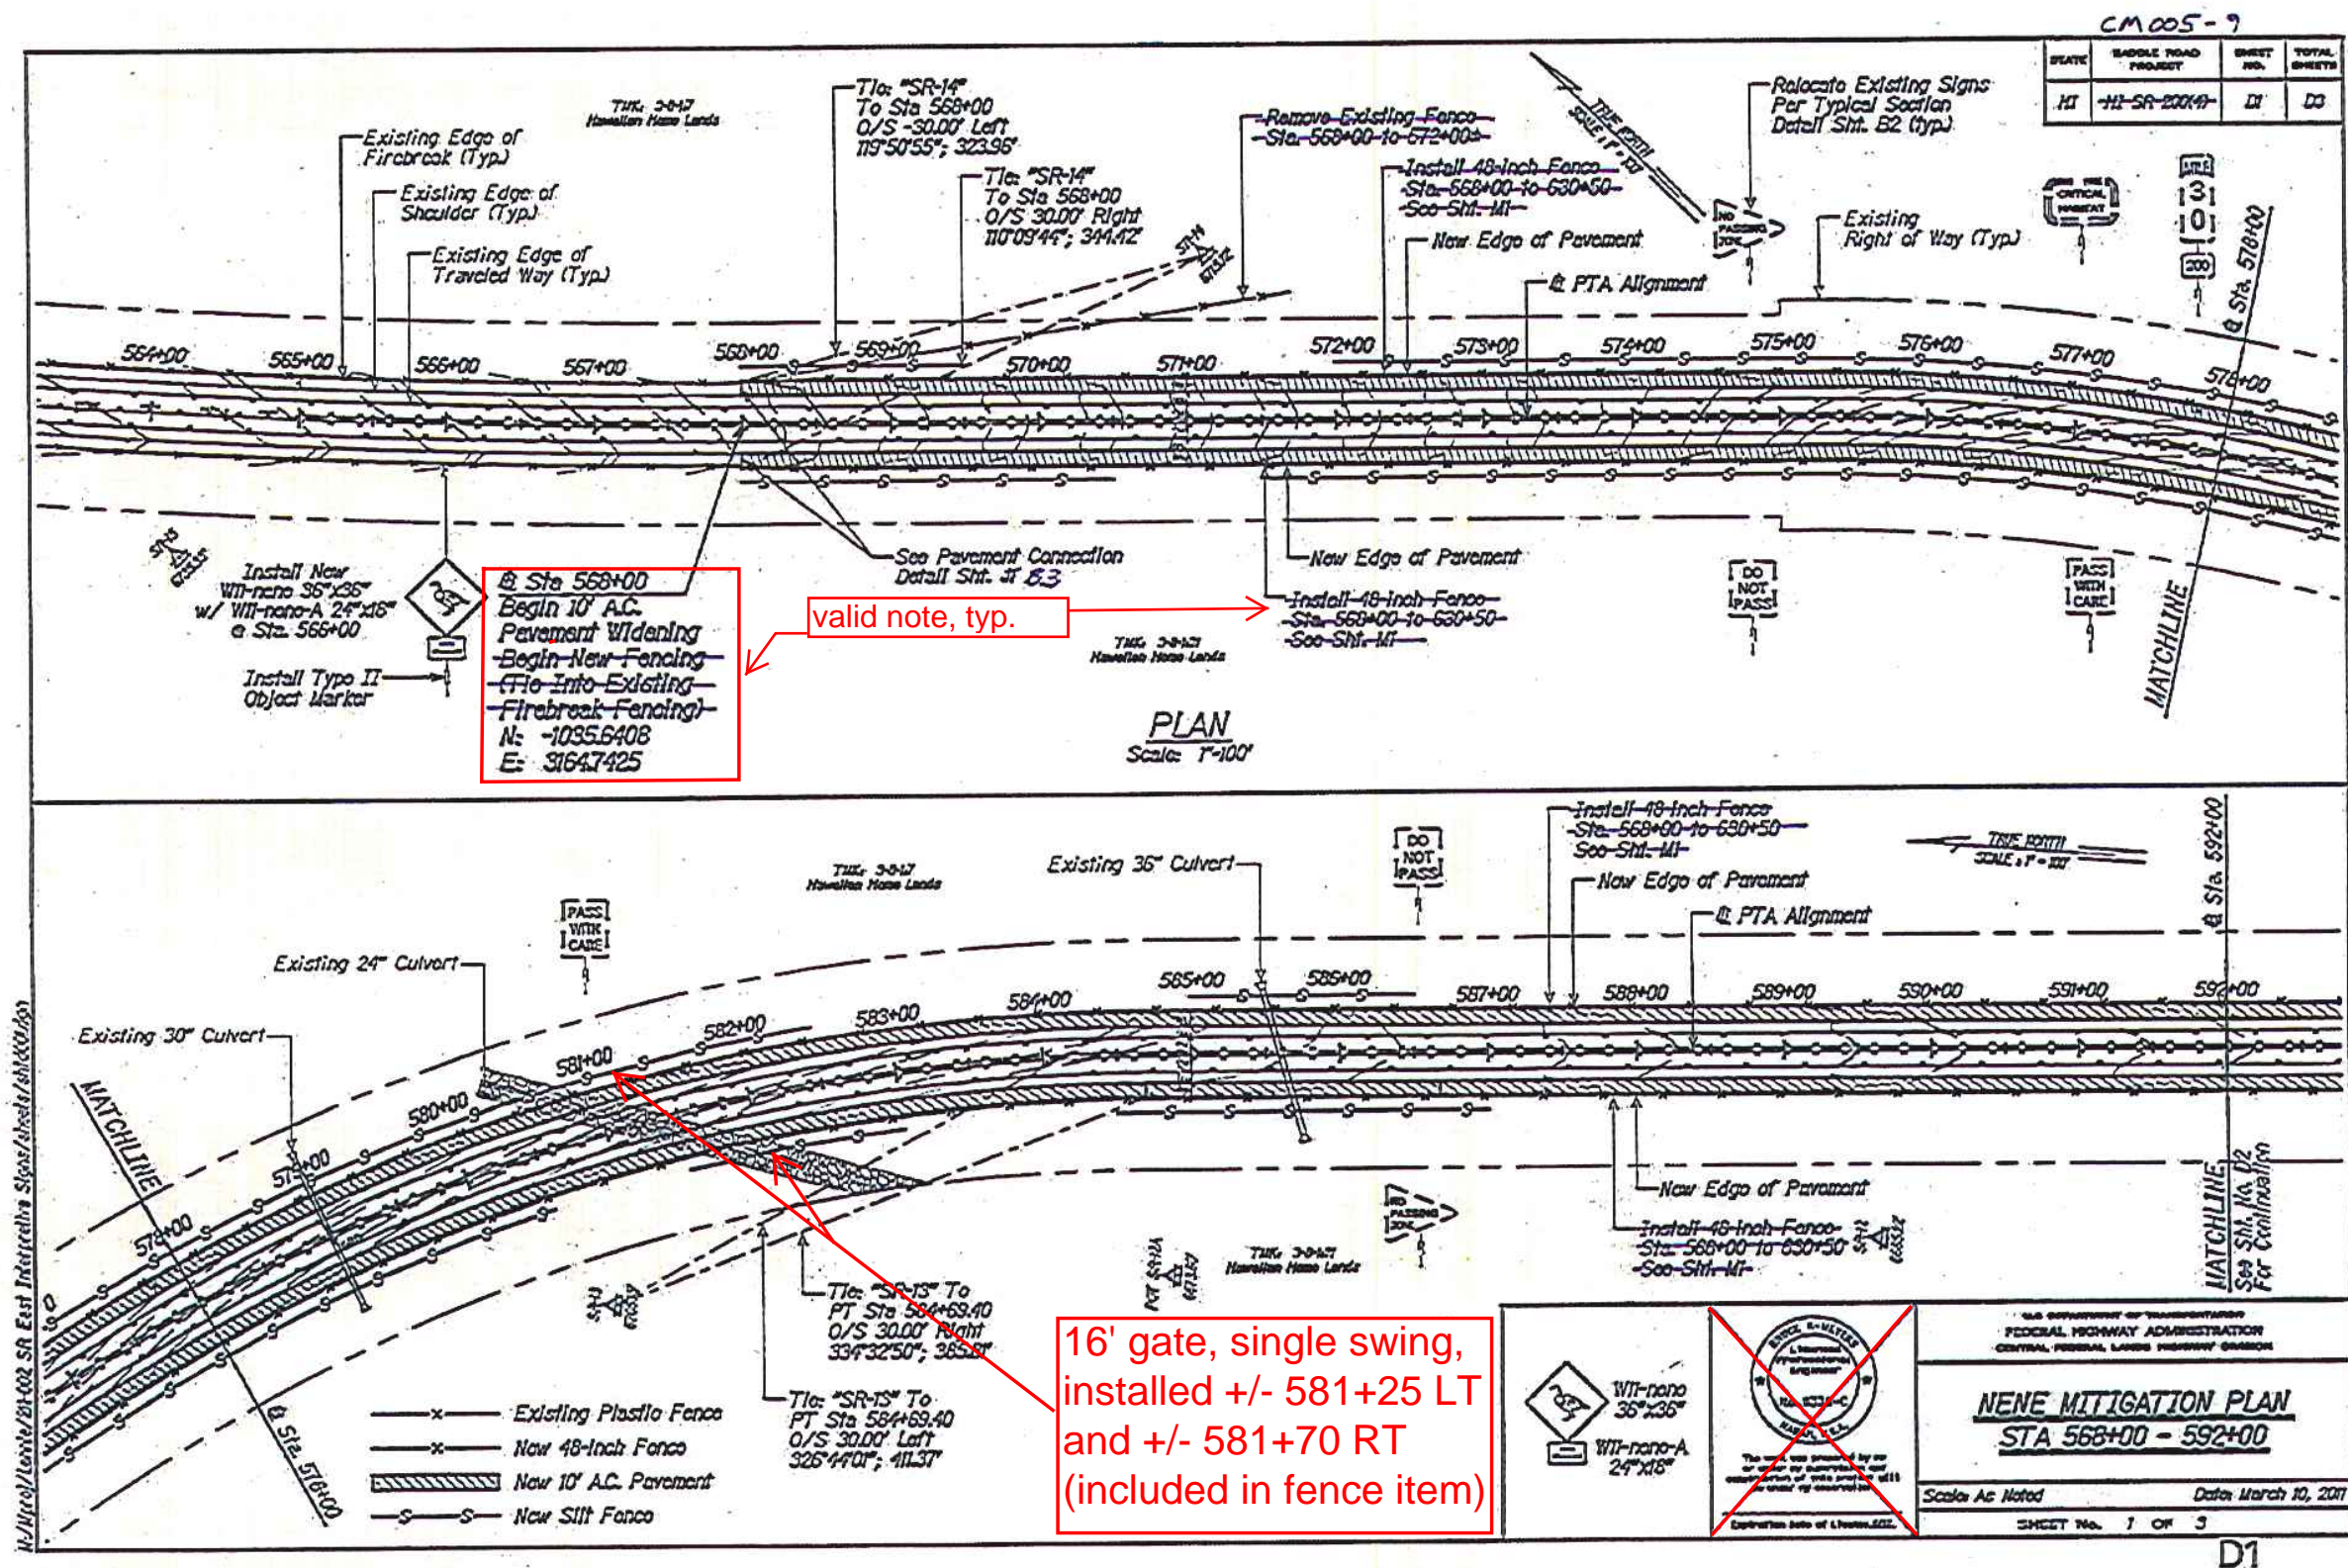
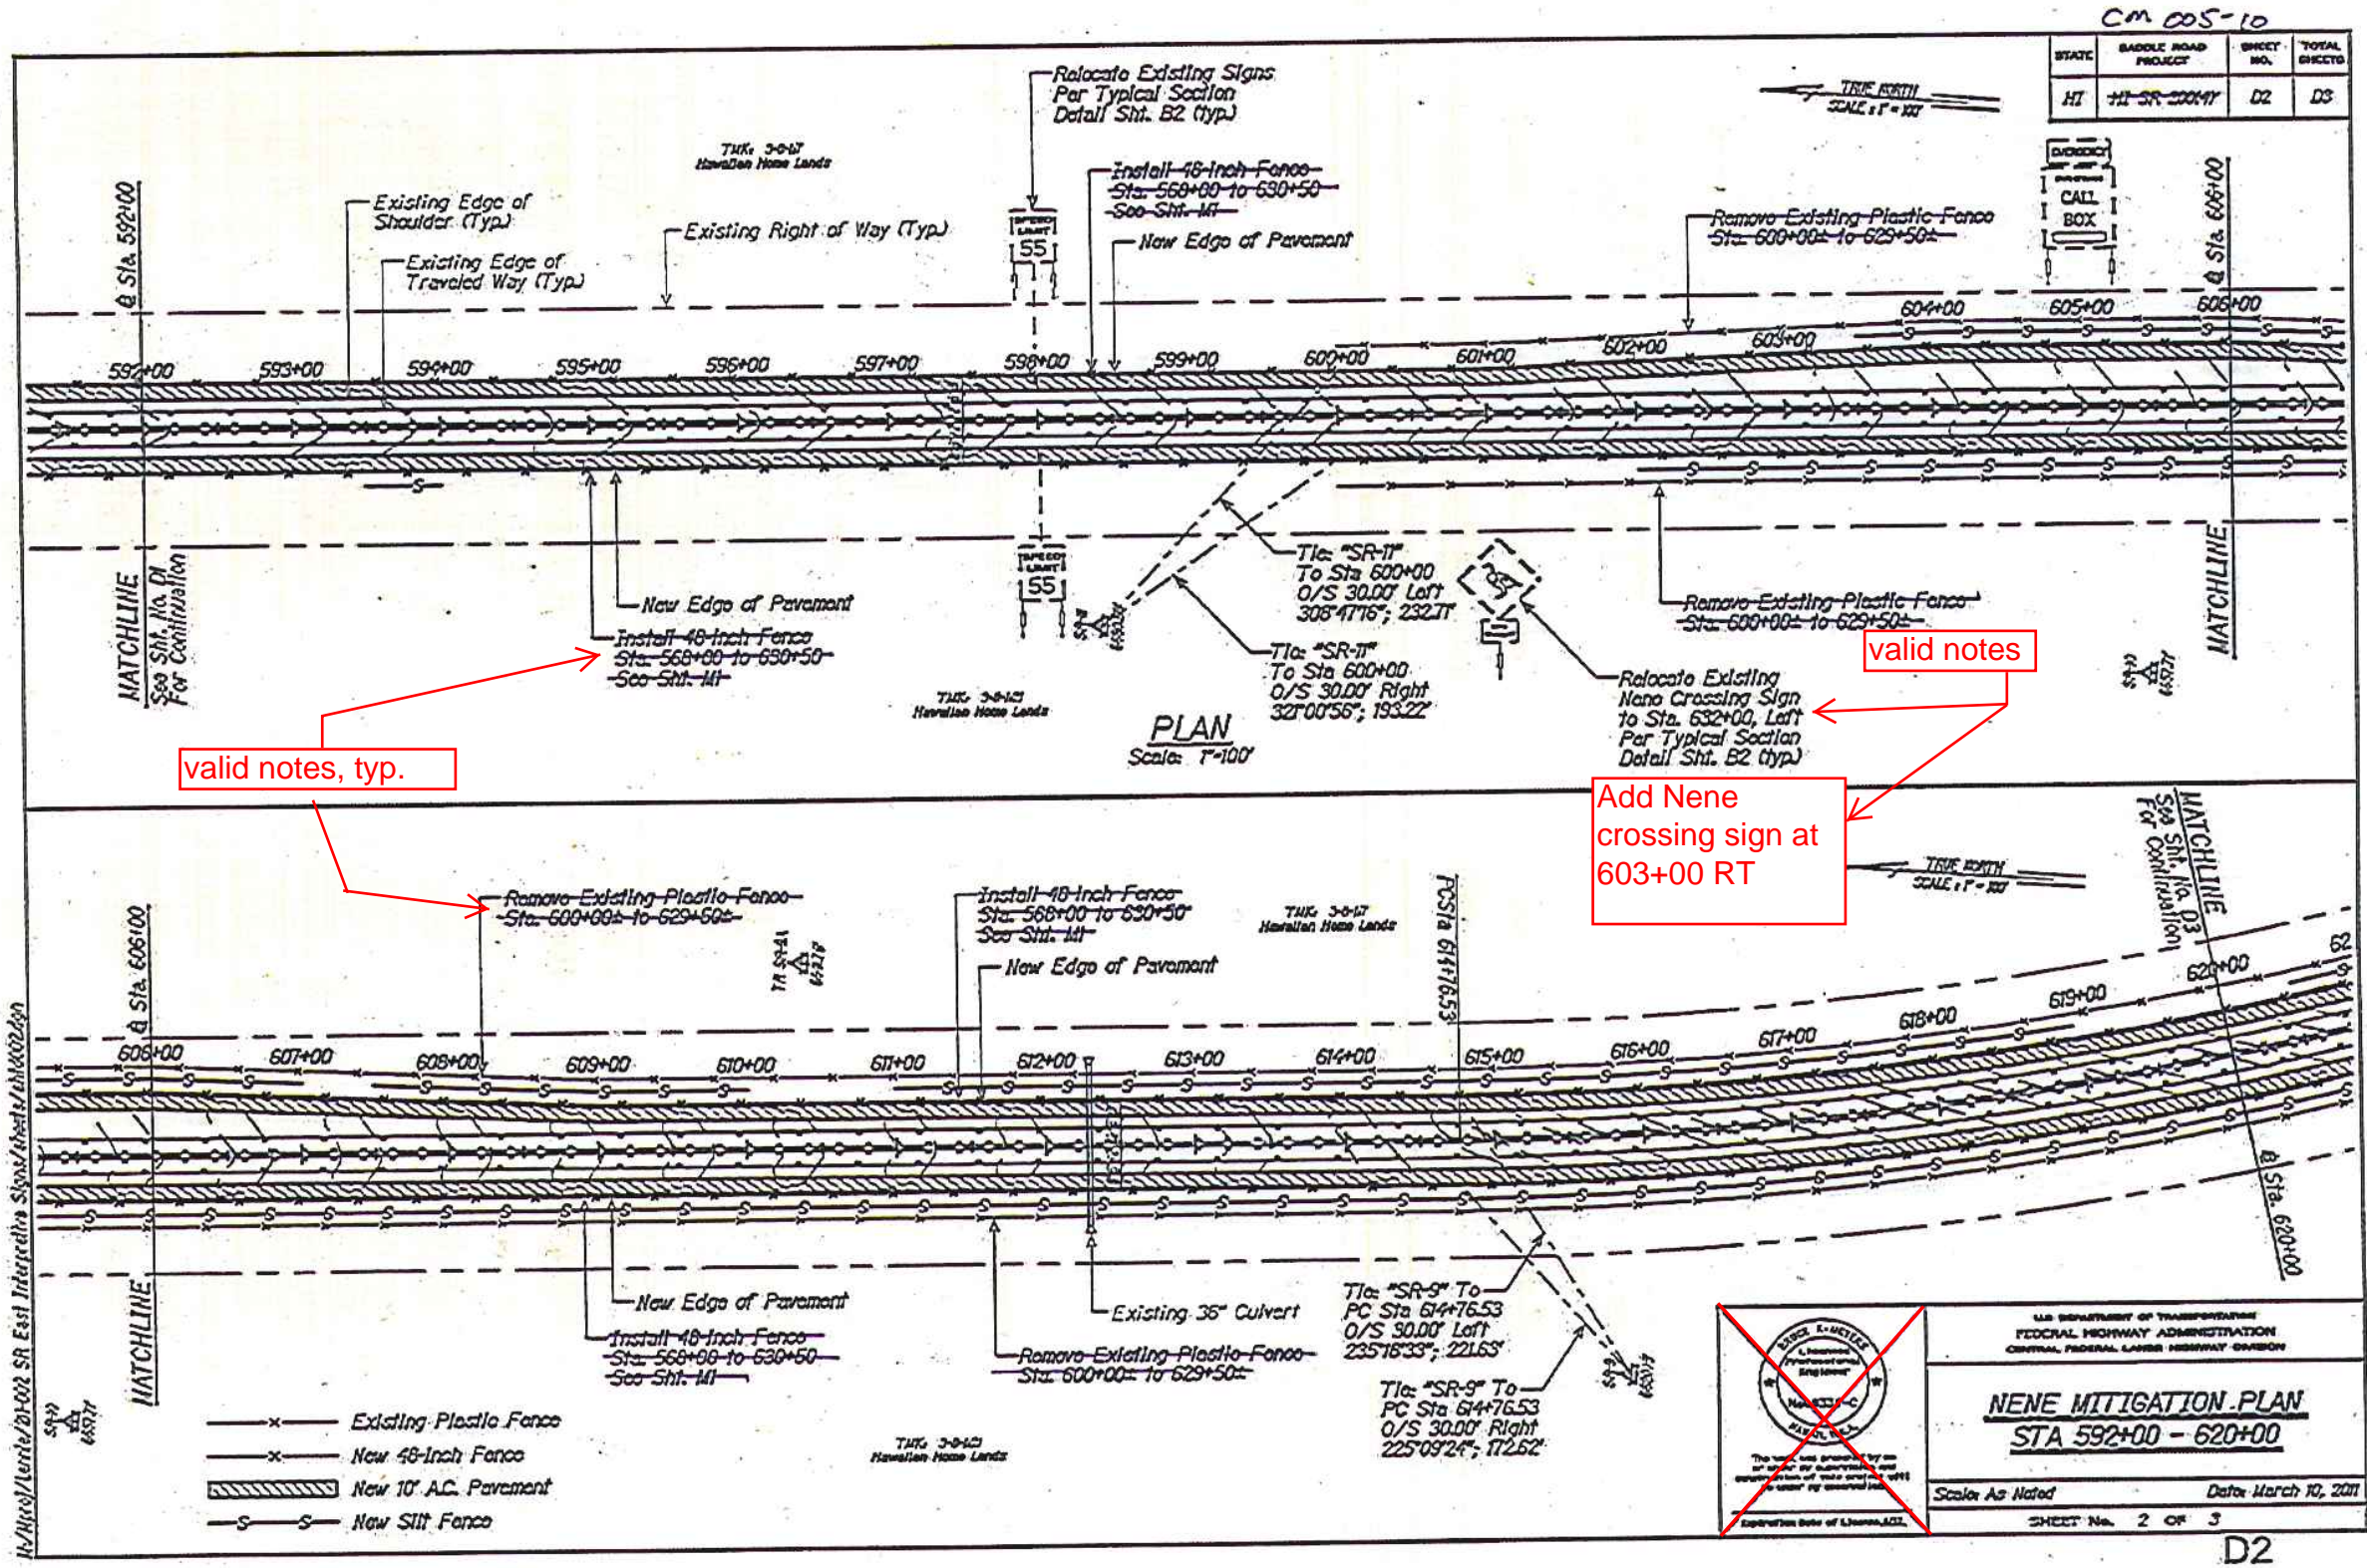
Comments relative to 48 inch and plastic fences are valid and should not be struck out. Changes to stationing only.

Comments relative to 48 inch and plastic fences are valid and should not be struck out. Changes to stationing only.

Comments relative to 48 inch and plastic fences are valid and should not be struck out. Changes to stationing only.
